ADDENDUM
to
AMENDMENT TO MDDP
for
COTTAGES AT WOODMEN HEIGHTS
and
FINAL DRAINAGE REPORT
for
COTTAGES AT WOODMEN HEIGHTS FILINGS NO. 1 & 2

Project #: 21369-00CSCV

SUMMARY OF ADDENDUM CHANGES TO APPROVED AMENDMENT TO MDDP

**STORM DRAIN
 PLAN & PROFILE**

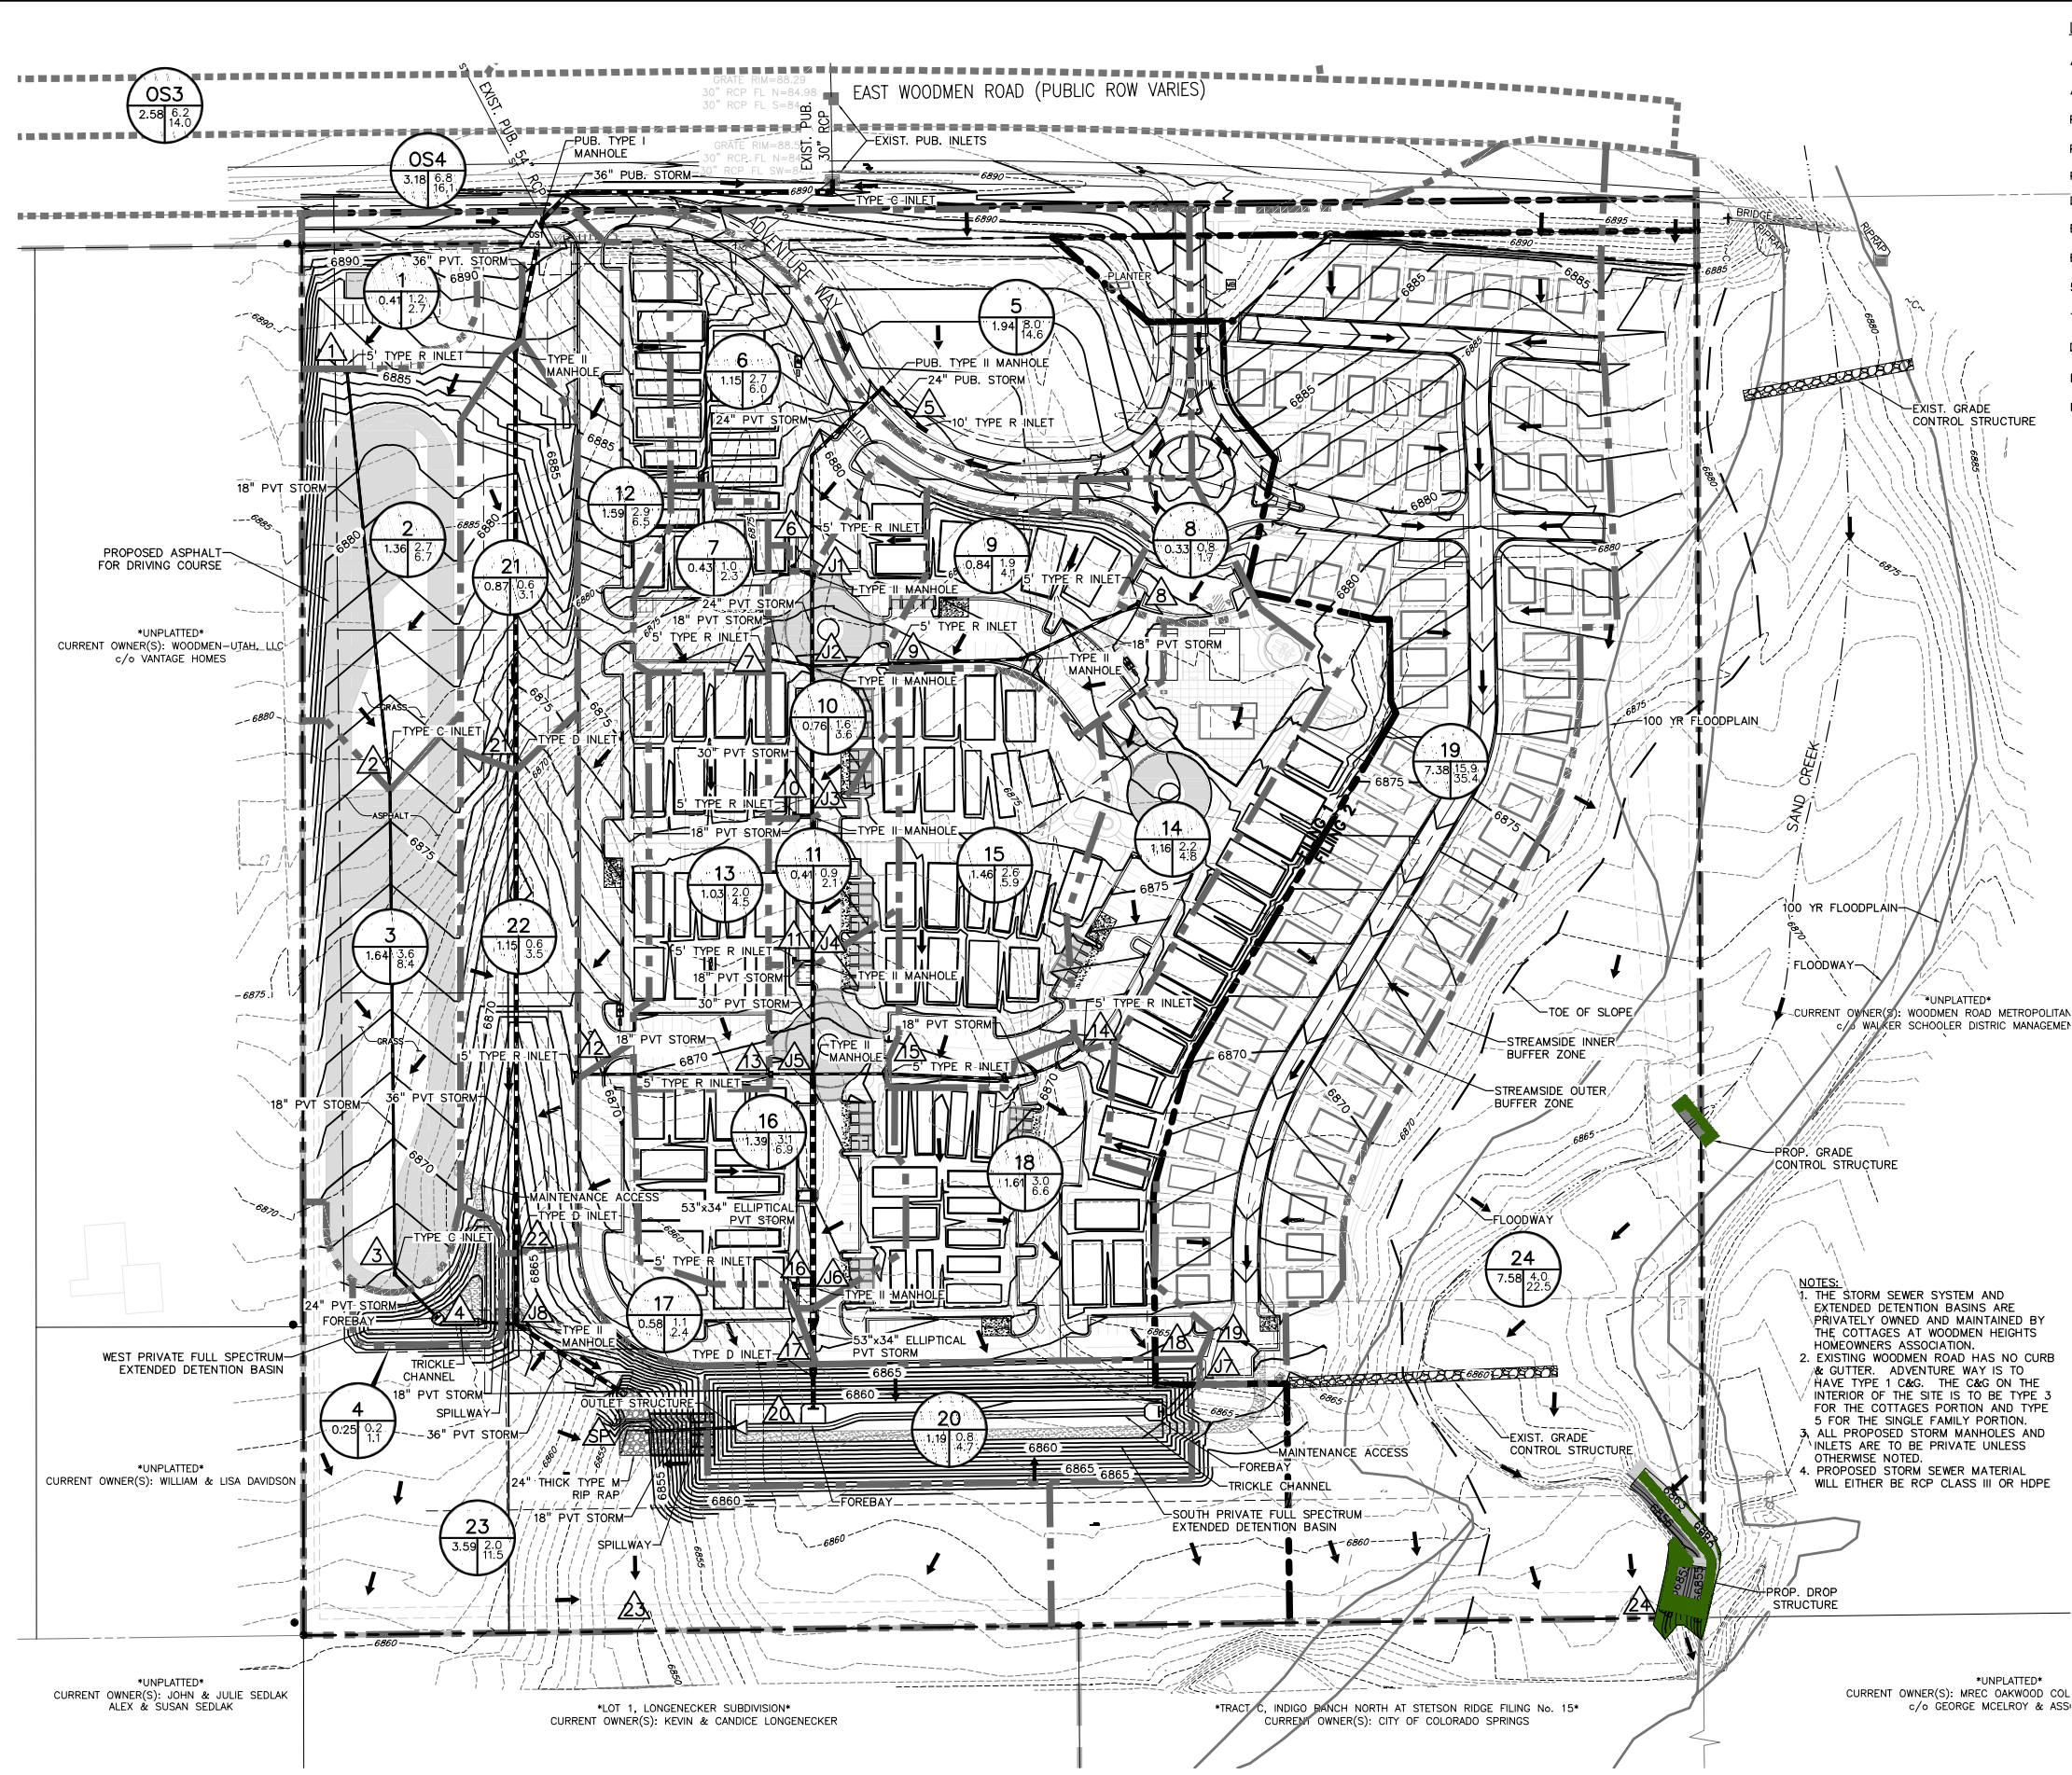
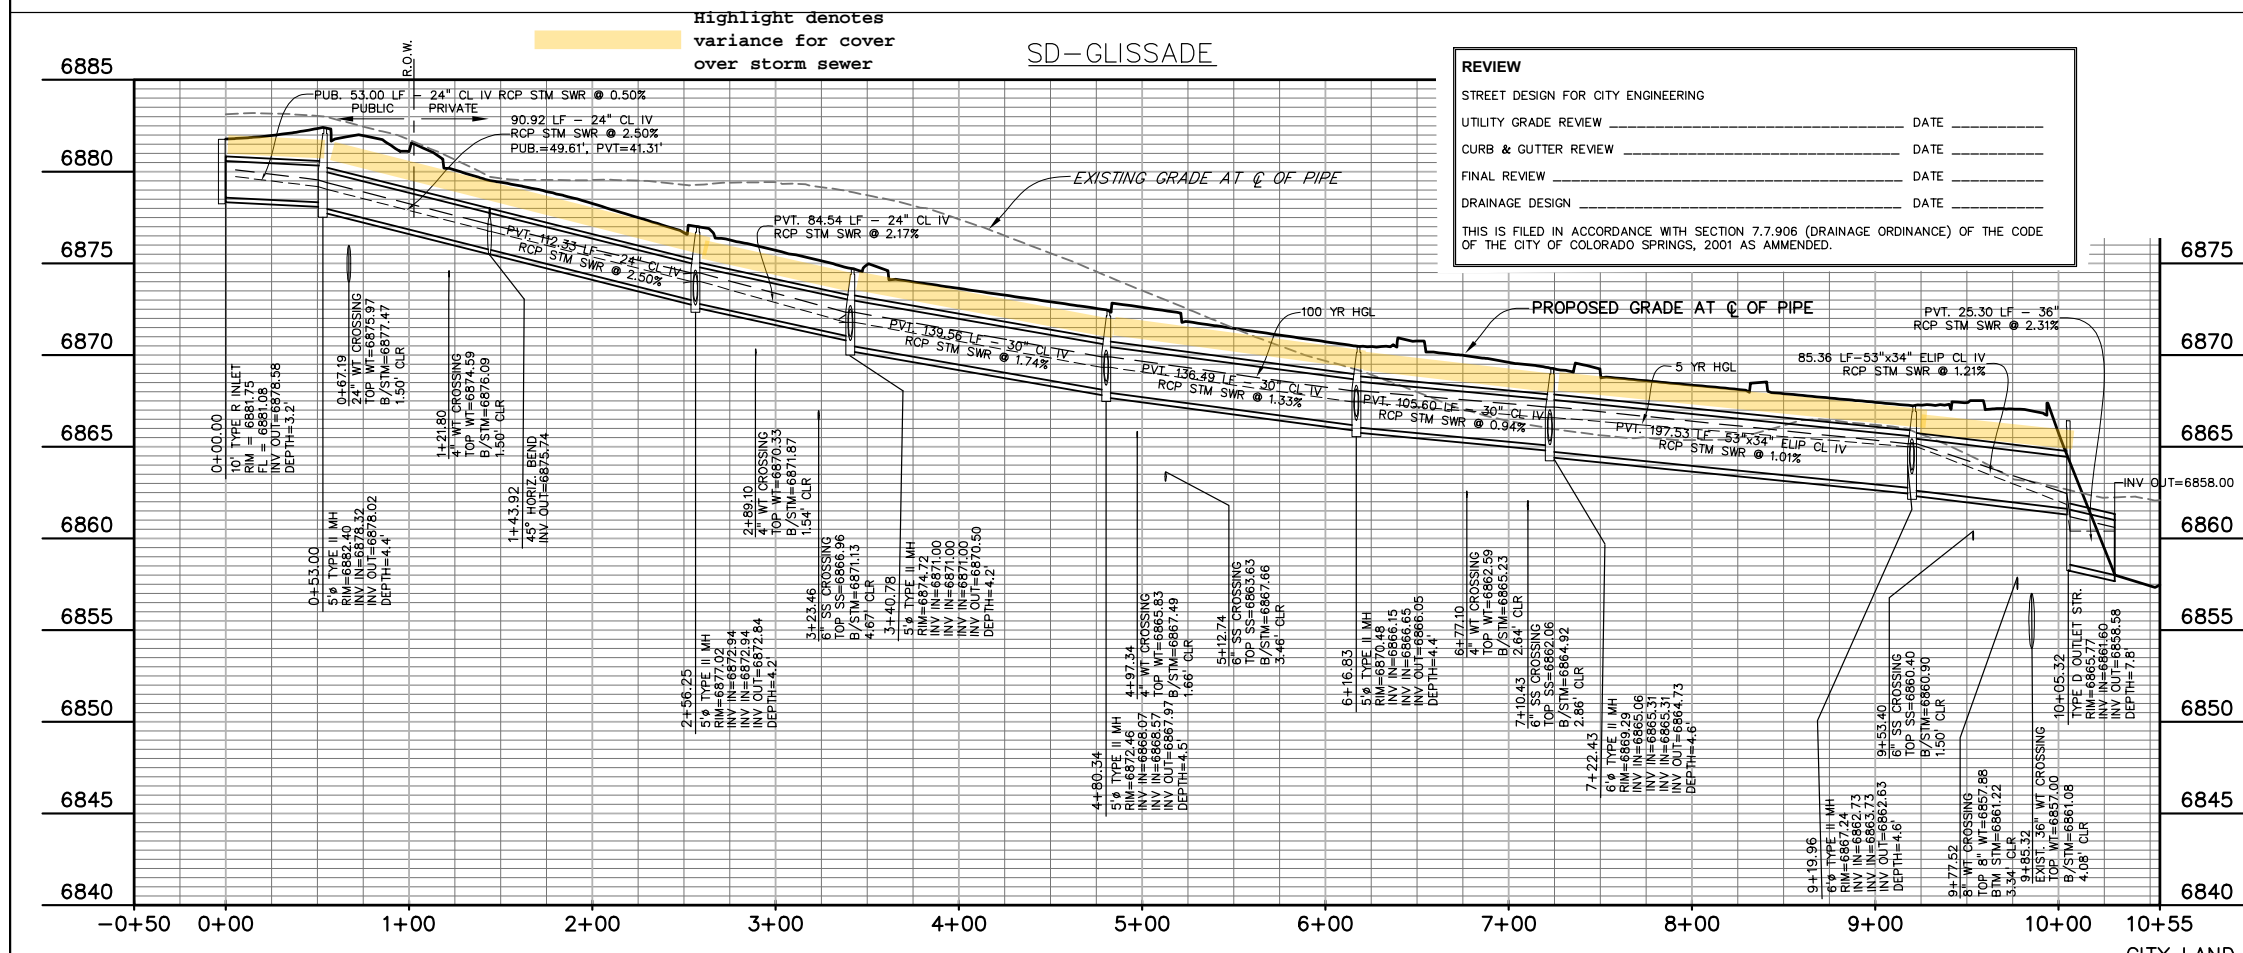
1. Chapter 9, Section 4.2 Cover in Roadways. The criteria states that minimum cover of 1 foot should be provided below pavement subgrade.

This variance request covers a reach of 24" circular to 42" elliptical equivalent private storm sewer pipe located in Glissade Grove, a proposed private street. In order for the storm sewer to adequately outfall and cross an existing CSU 36" transmission water main and proposed water and sanitary sewer utilities that are at critical grade with no less than 18" of clearance, the storm pipe in this reach (Sheet SD-4) is shallower than typical. The resultant cover over the storm sewer is less than 1' below pavement subgrade. At this time, pavement subgrade depth is unknown until a pavement design report is completed after wet utilities have been installed, however the minimum clearance provided between top of pipe and finished grade is 1.3' up to 2'+. The subject storm sewer is located in a low volume private street with most of the piping located under parking stalls and not in the drive aisle. Where the storm sewer does cross the roadway at the couple of private round-a-bouts, the surface paving will be concrete in these areas, providing more rigid support above the piping. This section of storm sewer will be Class IV RCP due to depth of cover for loading and pressure distribution.

2. Chapter 9, Section 6.2 Manhole Types. The criteria states that "...Inlets may not be used as junctions along trunk lines larger than 24" in diameter on public systems"

This request is for a Type C Inlet located in the proposed drainage ditch south of the Woodmen Road turn lane widening to be a junction structure. The proposed inlet replaces an existing sump area inlet that currently functions as a junction structure with a 30" RCP from the north, exiting southwest into an existing 30" RCP pipe. The prior inlet was installed by El Paso County when Woodmen Road was improved and widened to its current section. The roadway is now under City jurisdiction and a turn lane into Adventure way is now required so Woodmen Road will need to be widened
